## SAHARA R50-TO-R25 PRODUCT CIRCUIT CHANGES REQUIRING FCC CLASS II PERMISSIVE FILING

Figure 1. ReFLEX 50 Power Management

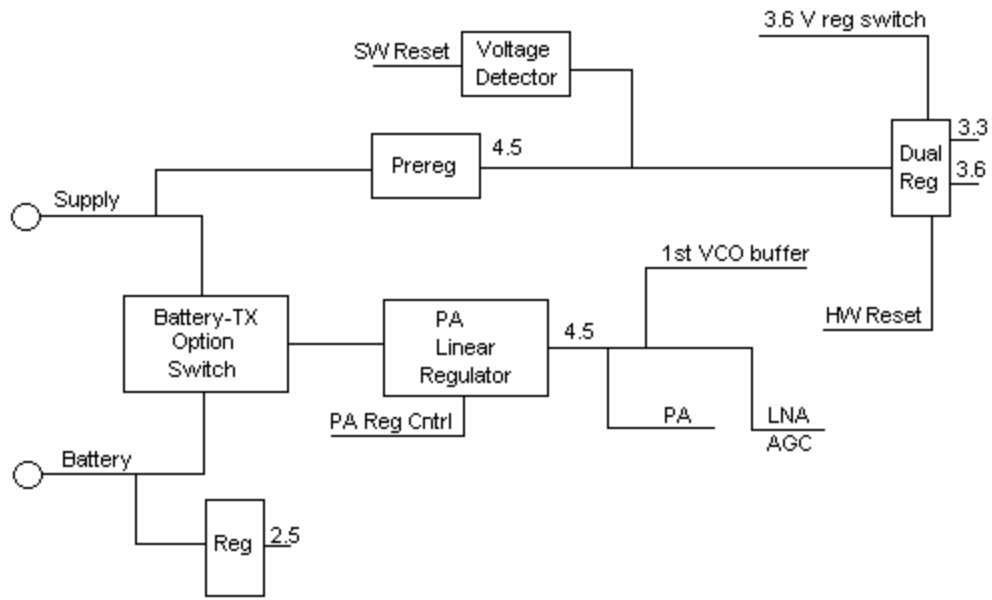
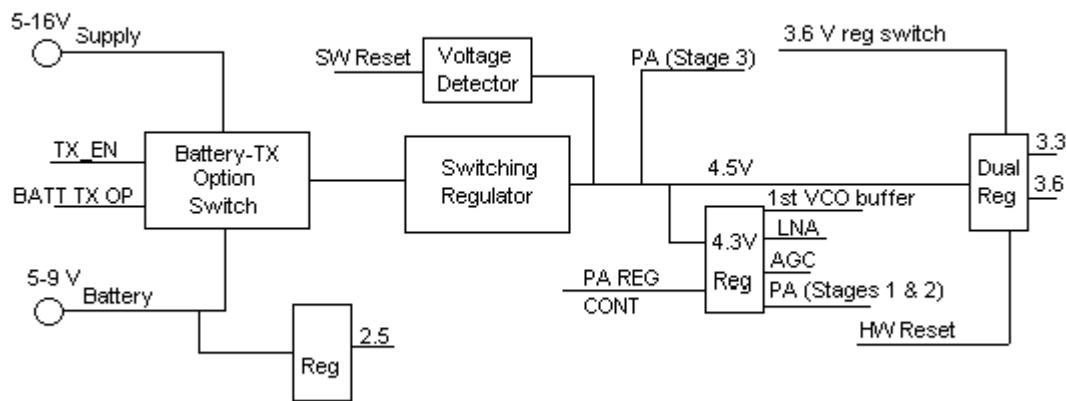
- Power management architecture for improved thermal operation and higher maximum operating voltage (see Figures 1 and 2). Transmit spurs can be observed at  $\pm$  500 kHz offsets from the carrier. These spurs are due to the AM-to-PM conversion of the switching regulator's voltage ripple present at the supply connections of the transmitter power amplifier U770. U770 is a 3-stage amplifier IC.

Details: Replaced 4.5 V linear regulators U230 and U240 with one (1) 4.5 V switching regulator (U240). A 4.3 V linear regulator (U230) was added to the output of U240 for cleaner supply to critical RF stages. Also includes changes to the regulators' application circuitry (pass transistors, bias resistors, capacitors, and inductors).

For the R50 product, all three stages of U770 were supplied DC current by the 4.5 V linear regulator U240. For the R25 product, the first two stages of U770 are supplied DC current by the 4.3 V linear regulator U230 to reduce spur generation, as these are DC supply-ripple sensitive stages. The third stage of U770 is supplied DC current by the 4.5 V switching regulator U240 since this stage is less sensitive to DC supply ripple and requires significantly more DC current than the first two stages of U770 (efficiency and thermal design requirement).

Figure 3. Spurious Emissions at Antenna Terminals: Carrier Frequency at  $\pm 25$  MHz  
(HP 8594E Spectrum Analyzer)

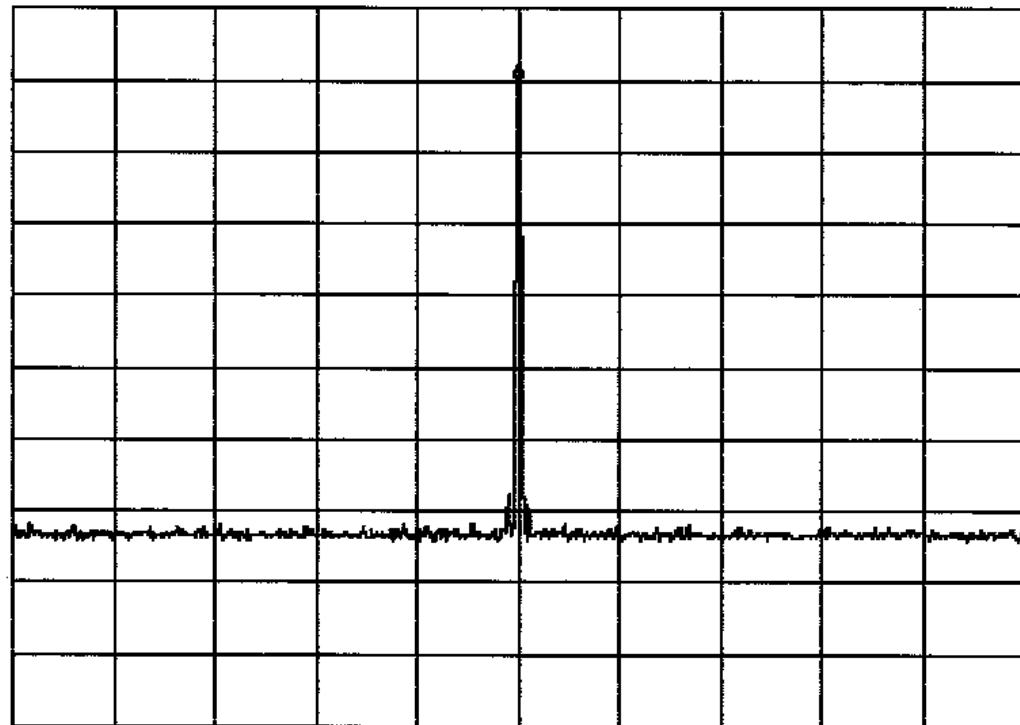
See Figures 3, 4, and 5 for transmitter spectral performance that was affected.
